**TOWN OF MOUNTAIN VILLAGE  
REGULAR DESIGN REVIEW BOARD MEETING AGENDA  
THURSDAY NOVEMBER 7, 2024, 10:00 AM  
MOUNTAIN VILLAGE TOWN HALL  
455 MOUNTAIN VILLAGE BLVD, MOUNTAIN VILLAGE, COLORADO  
TO BE HELD HYBRID THROUGH ZOOM:  
<https://us06web.zoom.us/j/89842973313>  
Meeting ID: 898 4297 3313**

**TO:** Mountain Village Design Review Board  
**FROM:** Claire Perez, Planner II  
**FOR:** Design Review Board Public Hearing; November 7, 2024  
**DATE:** October 23, 2024  
**RE:** Staff Memo – Final Architecture Review (FAR) for Lot 649R unit 10, TBD Boulders Way.

**TO:** Mountain Village Design Review Board  
**FROM:** Drew Nelson, Senior Planner  
**FOR:** Design Review Board Public Hearing; November 7, 2024  
**DATE:** October 30, 2024  
**RE:** Staff Memo – Initial Architecture and Site Review (IASR) Lot 165 Unit 17R, TBD Cortina Drive, pursuant to the CDC

Sheet  
**C1.0**  
CIVIL PLAN

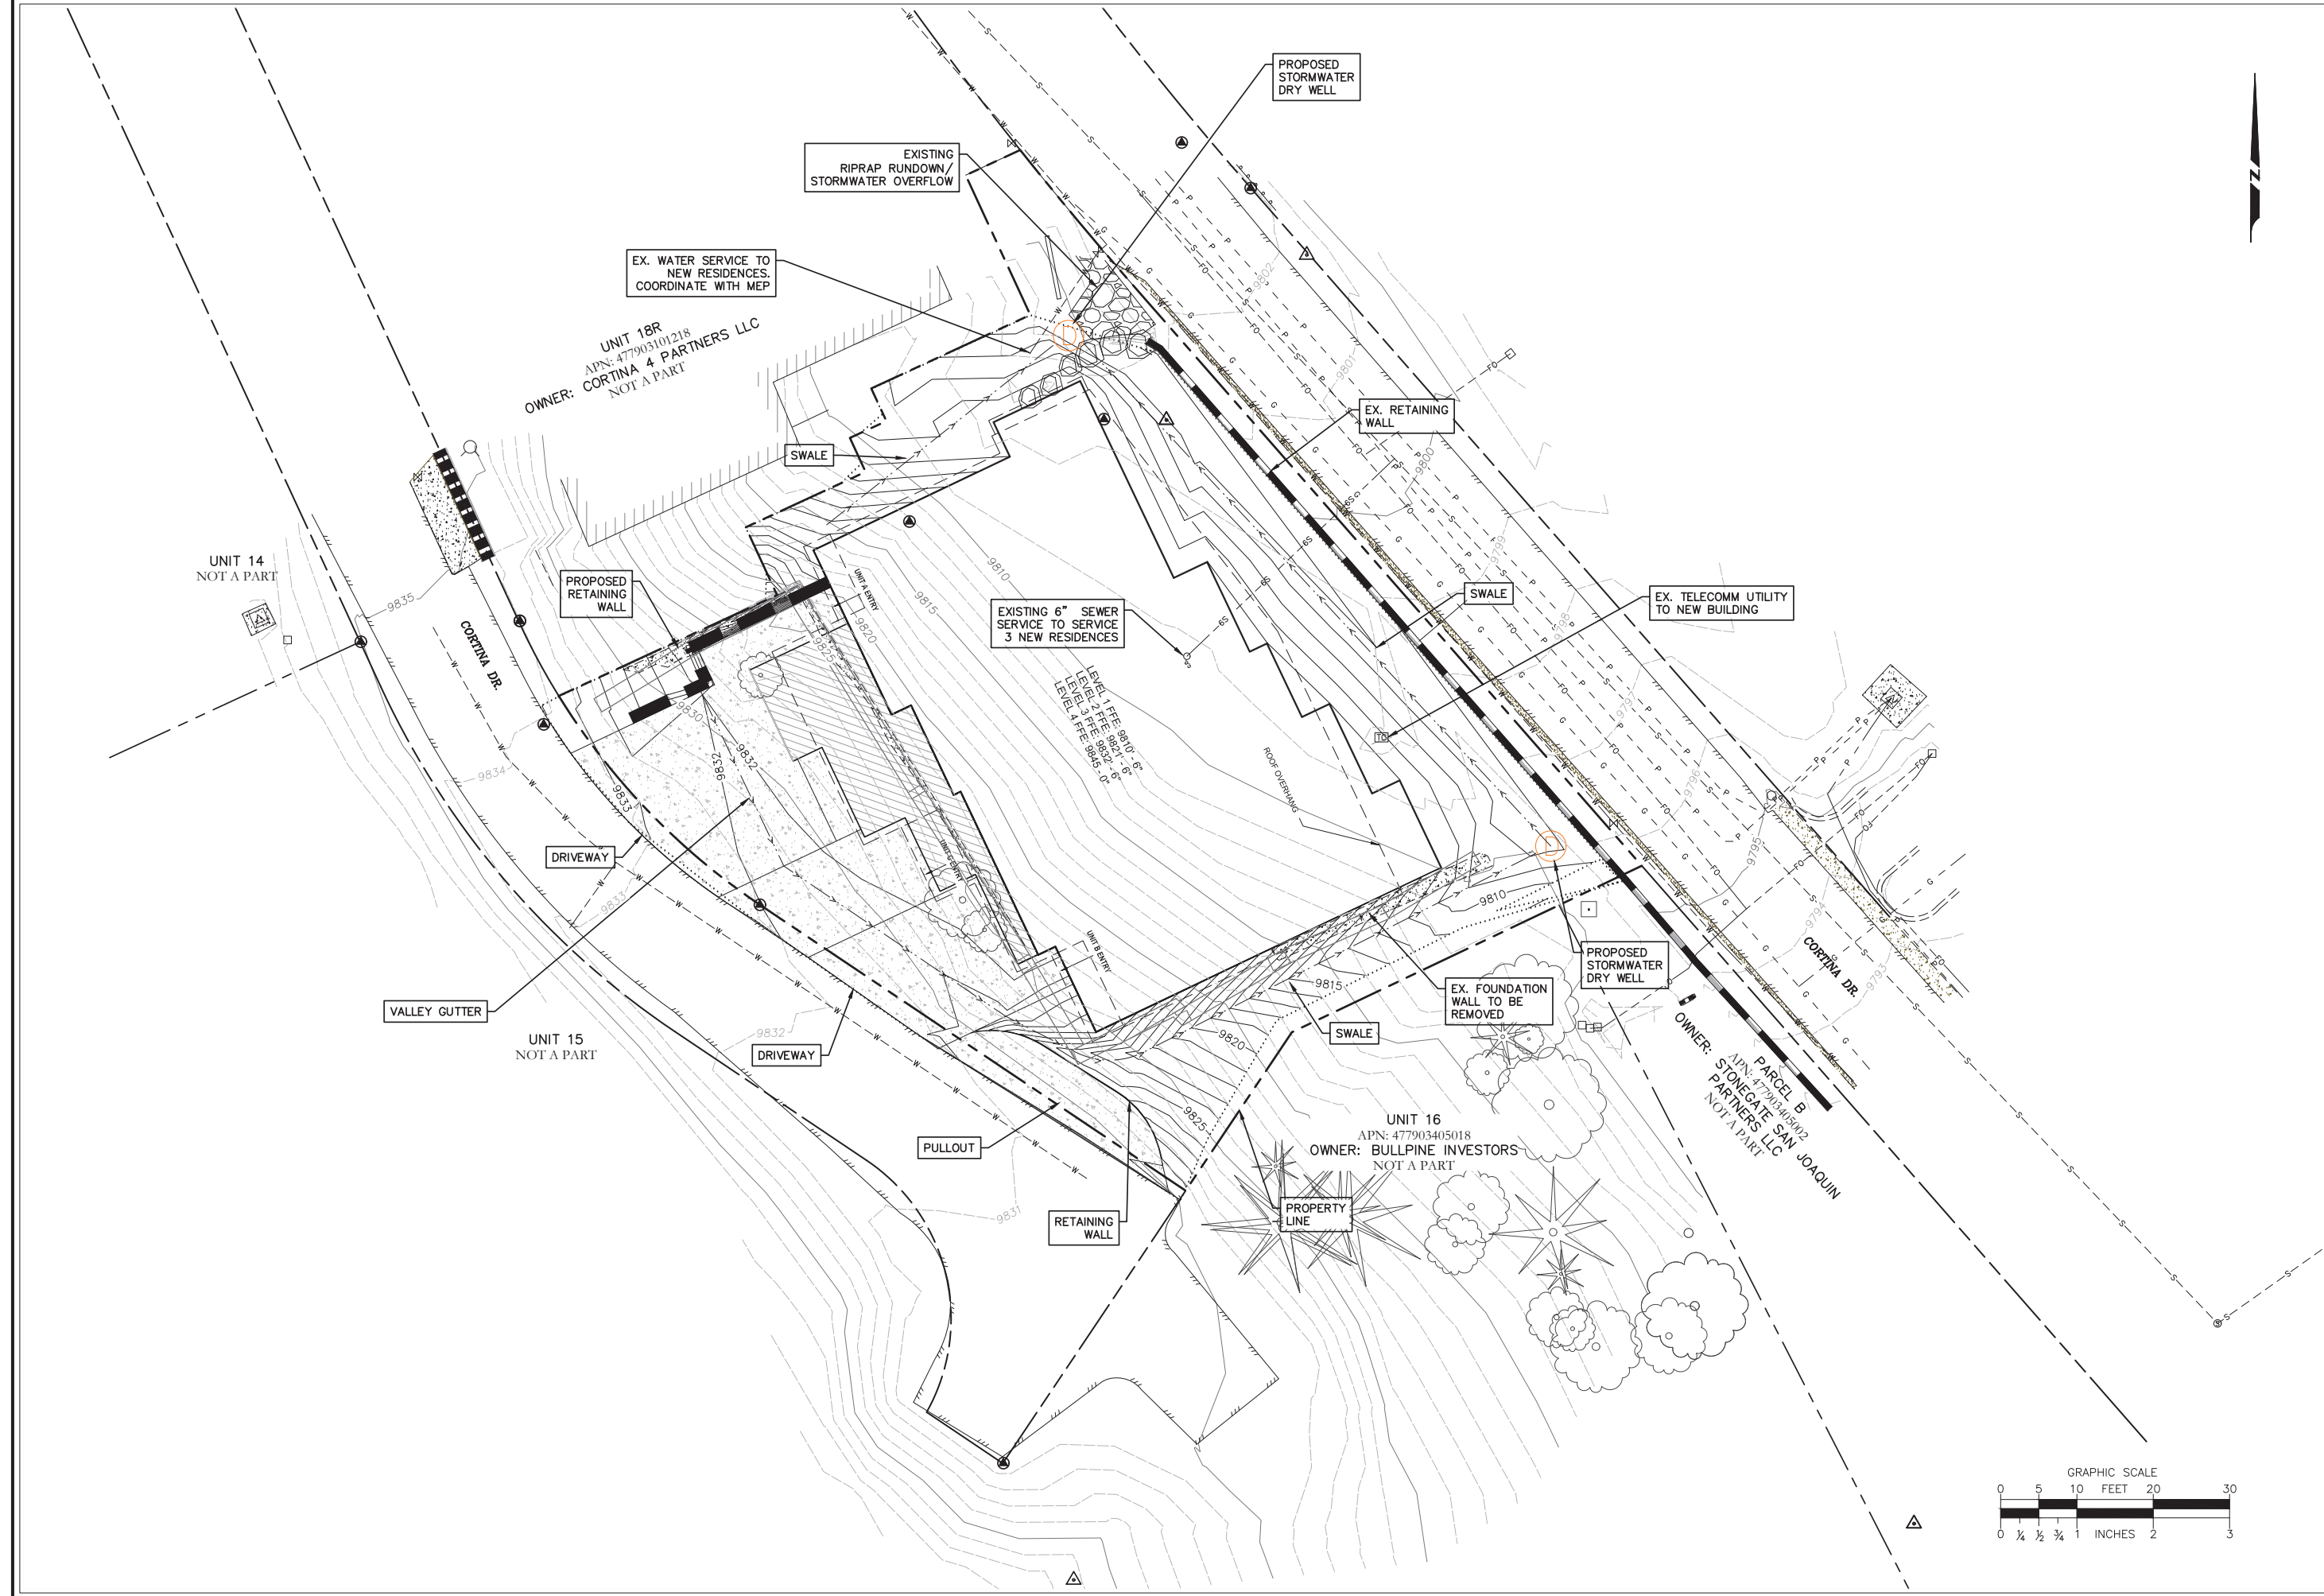
*Staff: The driveways proposed for the individual units appear to be short and relatively flat, per the civil design plans shown on sheet C1.0. The civil plans do not indicate driveway slope, which needs to meet the grade requirements of Section 17.6.6.B.4 of the CDC. Prior to Final Architecture Review, the applicant shall provide driveway slope details to ensure compliance with the CDC of a maximum grade of eight percent (8%) overall and five percent (5%) for the first twenty feet (20') from the edge of the access tract.*
